SERVICE BULLETIN

from: TRIO-KENWOOD COMMUNICATIONS, INC.

SUBJECT: SERVICE NOTE ON DG-1

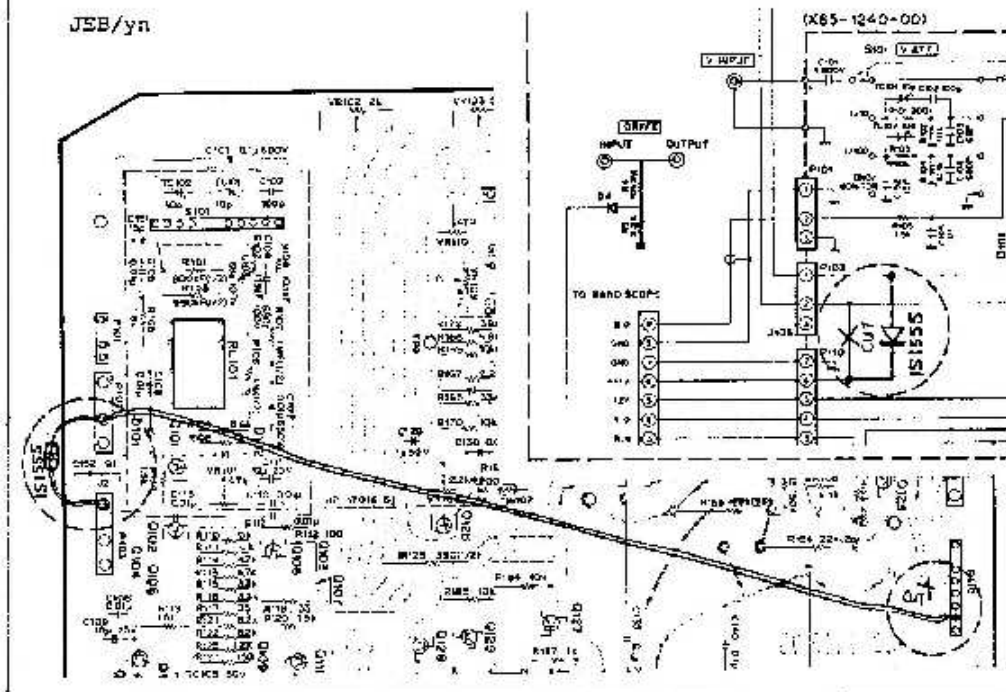
BS-5 users may report ignition-like interference on 80 & 40M from their SM-220 with BS-5. Noise will be heard between 3850-3870 KHz, and 7245- 7260KHz any time the scope is on.

The sweep signal mixes with the IF (carrier) frequency. This derived signal, or its second harmonic will usually be less than an S1 signal, unless the coax ground to the scope is opened, in which case S9 may be indicated.

On the SM-220 PCB X65-1240-00, change the BS-5 +11V DC supply point:

1. Cut the foil path between connector P110 pin 6 & Connector P103 pin 2.
2. Install a 1S1555 diode between Connector P110 pin 6 and Connector P103 pin 1.

New Part: 1S1555 V11-0076-05

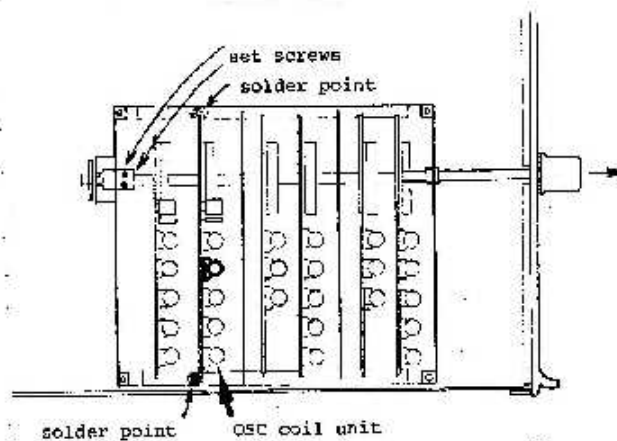
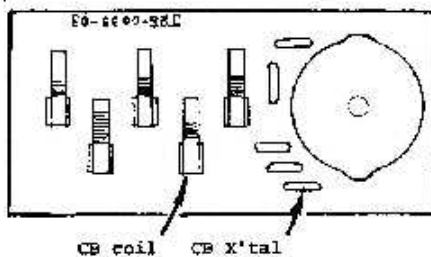
One of the items in the FCC's expansion of the CB band to 40 channels was to require all receivers that have a specific CB or 11 meter band be type accepted. The R-599A and R-599D receivers have not been type accepted and we do not plan to have this done as they are designed for the ham bands. We have therefore removed the CB position from the current production of R-599D receivers and this band position is now labeled AUX.

This ruling also applies to any used R-599A or R-599D receiver you may have in stock. The following instructions are for removing the CB band. This will satisfy the FCC and make the receiver saleable.

1. Remove top cover.
2. Remove bottom cover.
3. Remove shield plate from coil pack.
4. Set band switch to 14MHz.
5. Remove the black wire from the OSC Coil Unit. (This wire is on the top side.)
6. Loosen screws on shaft coupling and slide shaft out about 2 inches.
7. Unsolder the OSC Coil Unit from the mounting bracket and remove it from the coil pack.
8. Unsolder and remove the CB coil and crystal.
9. Replace the OSC Coil Unit and solder it in.
10. Slide the band switch shaft in place, making sure that each wafer is properly indexed.
11. Resolder the black wire to the OSC Coil Unit.
12. Replace all covers.
13. Check for proper operation.

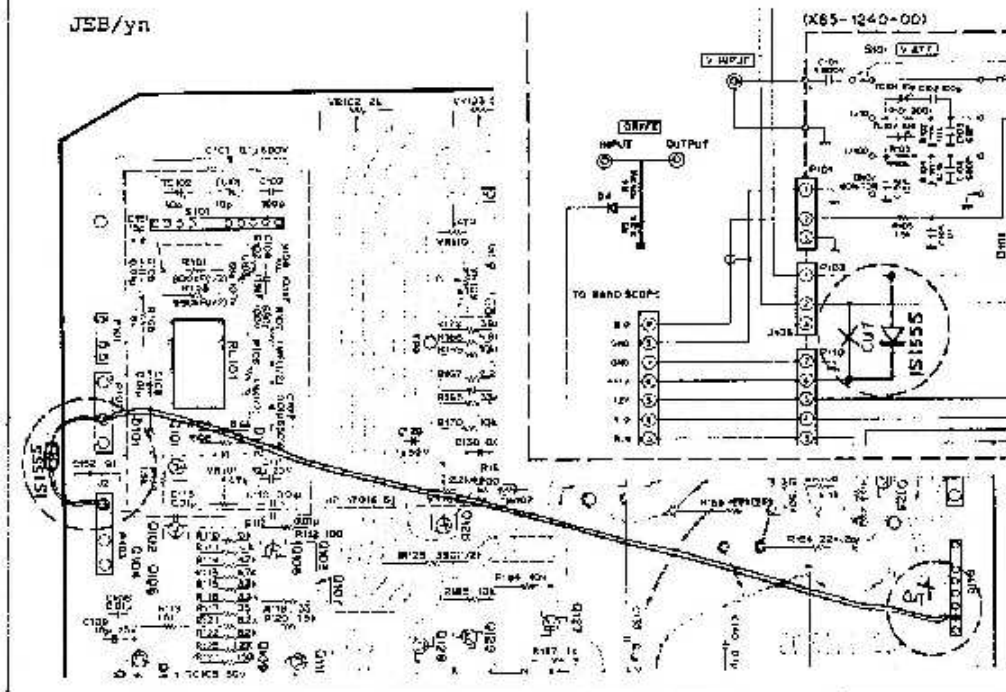
BS-5 users may report ignition-like interference on 80 & 40M from their SM-220 with BS-5. Noise will be heard between 3850-3870 KHz, and 7245- 7260KHz any time the scope is on.

The sweep signal mixes with the IF (carrier) frequency. This derived signal, or its second harmonic will usually be less than an S1 signal, unless the coax ground to the scope is opened, in which case S9 may be indicated.

On the SM-220 PCB X65-1240-00, change the BS-5 +11V DC supply point:

1. Cut the foil path between connector P110 pin 6 & Connector P103 pin 2.
2. Install a 1S1555 diode between Connector P110 pin 6 and Connector P103 pin 1.

New Part: 1S1555 V11-0076-05

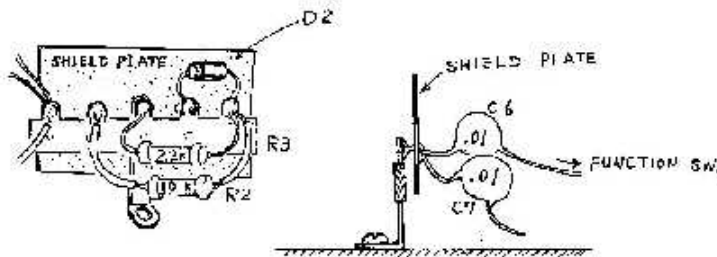
For Sweep interference from the SM-220 back into either a TS-520, or TS-180S, install an additional shield in the RF compartment in the SM-220.

1. Disconnect the power cord from the back of the scope.
2. Remove the scope top cover.
3. Loosen the Function and RF ATT shaft couplers using a 1.5mm allen key. Withdraw the shafts away from the RF compartment.
4. Remove RF compartment screws from the rear panel.
5. Remove 4 screws to open the RF comp.
6. Remove one screw to remove internal shield.
7. C6, a .01uF, runs from the Function Switch to a ground point under the RF ATT switch. Cut the ground lead and shorten so the cap is grounded to the ground point under the function switch.
8. R2, a 10k ohm, is attached to the terminal strip directly under the function switch. Reposition this resistor from the top of the terminal strip to the bottom of the strip.
9. Install the additional shield to the ground point under the function switch.
10. Reverse disassembly procedure to reassemble.

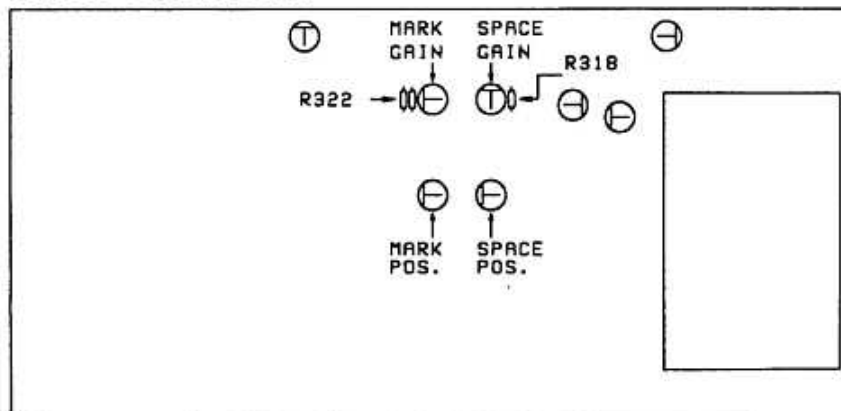
Some users of the SM-230 have reported that the MARK and SPACE gain adjustments do not sufficiently reduce the signals to display them on the CRT. The following modification will correct this condition.

680 OHM 1/8W RESISTOR RD14CB2B681J QTY. 2

1. Disconnect the power cord and control cables.
2. Remove the top cover (6 screws).
3. Locate the Horizontal unit. This board is vertically mounted on the right side of the SM-230.
4. Locate resistors R318 and R322 on the Horizontal unit.
5. Replace R318 and R322 with 680 ohm resistors.
6. Assemble the SM-230.
7. Adjust the MARK and SPACE gain adjustments as necessary to obtain the correct cross pattern.

FOIL SIDE OF BOARD

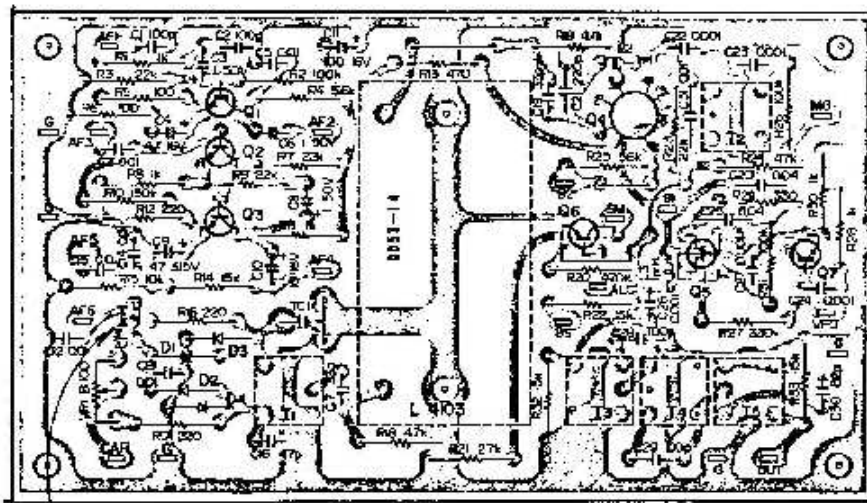
There have been some cases of 120Hz hum in the T-599D. This may be reduced by removing L-1 (1mH) on the generator unit (X52-0009-00) and replacing it with a 47 ohm resistor. Shown below is the generator unit board with this change.

Figure 1 (Bottom side)

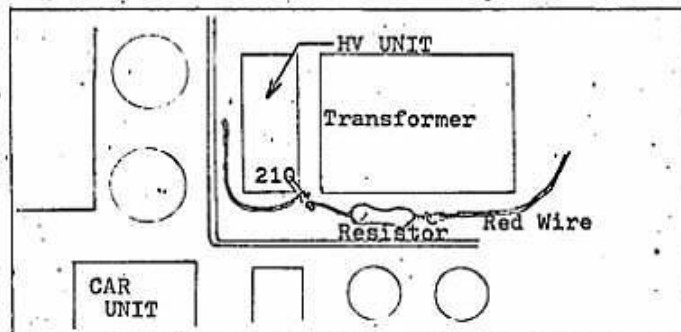
1. Cut wire (see figure 1) red color.
2. Insert 33Kohm resistor in series between red wire and pin 210.
3. Readjust bias current to 60ma.

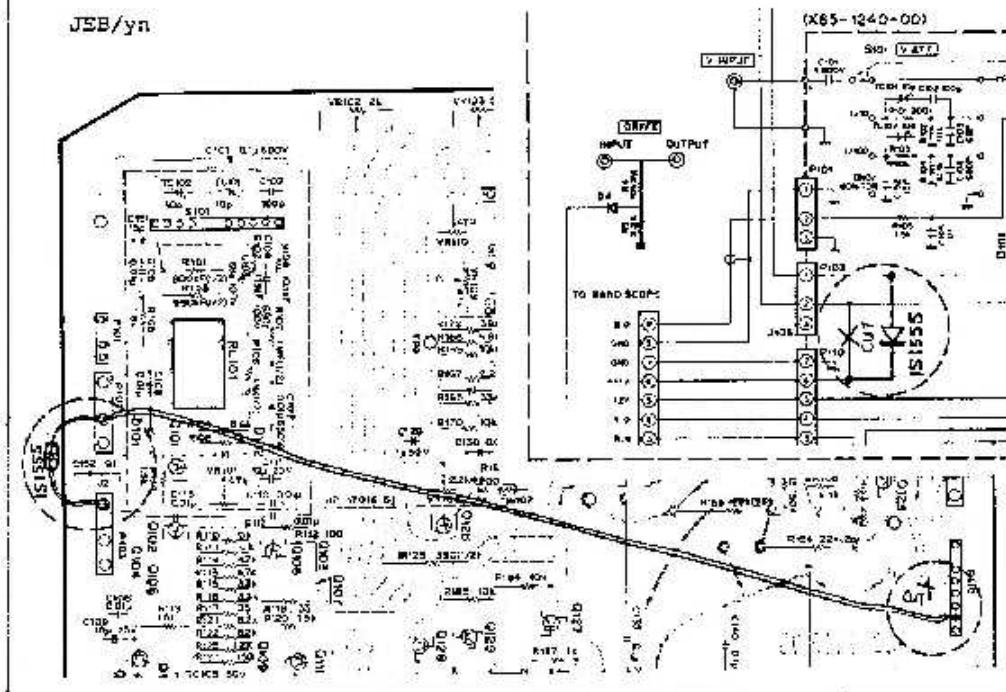
BS-5 users may report ignition-like interference on 80 & 40M from their SM-220 with BS-5. Noise will be heard between 3850-3870 KHz, and 7245- 7260KHz any time the scope is on.

The sweep signal mixes with the IF (carrier) frequency. This derived signal, or its second harmonic will usually be less than an S1 signal, unless the coax ground to the scope is opened, in which case S9 may be indicated.

On the SM-220 PCB X65-1240-00, change the BS-5 +11V DC supply point:

1. Cut the foil path between connector P110 pin 6 & Connector P103 pin 2.
2. Install a 1S1555 diode between Connector P110 pin 6 and Connector P103 pin 1.

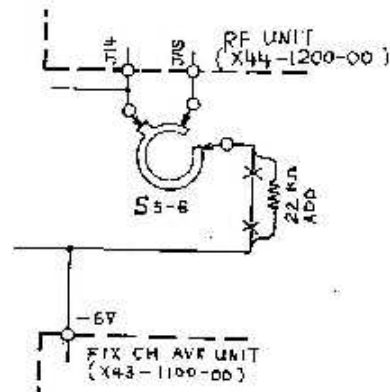
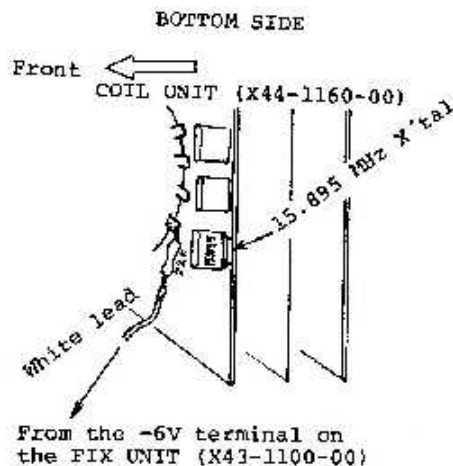
When troubleshooting a TS-520S, check all power supply voltages, including the -6V DC supply. Symptoms such as dead, blown 2A DC fuse and now dead, low RX, no TX, or similar may occur after switching between 80 & 40M.

Cause of failure may be traced to an intermittent shorting between the 14V DC & -6 DC supplies as the Band Switch is rotated between 40 & 80 M. This will weaken or destroy D8, 6V Zener on the FIX CH AVR unit. To prevent repeat failure, break the WHITE lead & install a 22k ohm $\frac{1}{4}$ W resistor at the Bandswitch S5-6, between the -6V supply line and switch terminal. And of course replace D8 on the FIX CH AVR unit, X43-1100-00.

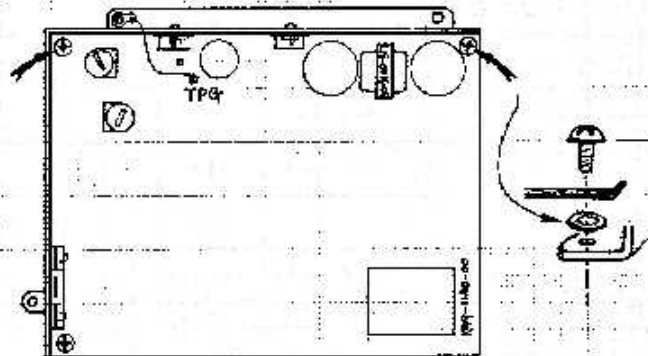
Some users may report an intermittent shift in display and operating frequency. This may typically be a 1 to 4 KHz random shift. Cause will be a loose grounding screw on the AF-AVR unit heat sink.

On the AF-AVR unit X49-1140-00, there are three self-tapping screws holding the aluminum heat sink to the PCB. These also supply the ground connection to that section of the board. Between the heat sink and PCB foil, add a tooth-lock washer N17-1030-41 at the two self-tapping screws shown. (The remaining screw already has a tooth-lock washer.) When replacing the board to the chassis, add a solder lug E23-0420-05 to the heat sink mounting screw as shown, and tighten all screws for this board. Solder an insulated lead between the TPG (Test Point Ground) wrap post adjacent to C81, and the added solder lug.

1. Remove the top cover (8 screws) and unplug the speaker.
2. Remove the bottom cover (8 screws).
3. Remove 5 screws holding the AF-AVR unit and swing the board over. Leads do not have to be unplugged.
4. Add two tooth-lock washers as shown.
5. Replace the circuit board and heat sink to the chassis, adding the solder lug as shown.
6. Solder a jumper between the TPG wrap post and the added solder lug.
7. Replace the top and bottom covers.

AF UNIT X49-1140-00

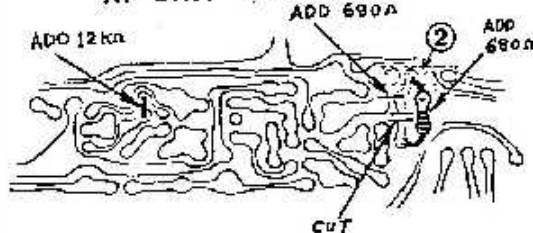
Across T2, (Fig. 1) add a 12KΩ (RD14CB2E123J)*

At Q21 (Fig. 2,3) add 2 pcs. 680Ω (RD14CB2E681J)*

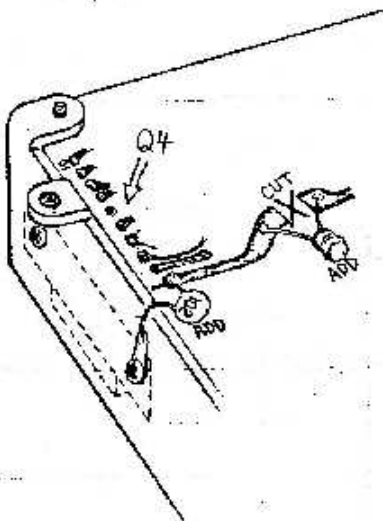
On the AF unit X49-1140-00 at Q4, cut the 12V DC B+ line between R47 and C28, and add a 1 μ H choke (L40-1092-02) in-line. Add a .01 μ F cap (C52-1710-36) from the IC pin 1 to ground, as shown using a 3mm lug (E23-0015-04) under the IC mounting screw on the Heat Sink.
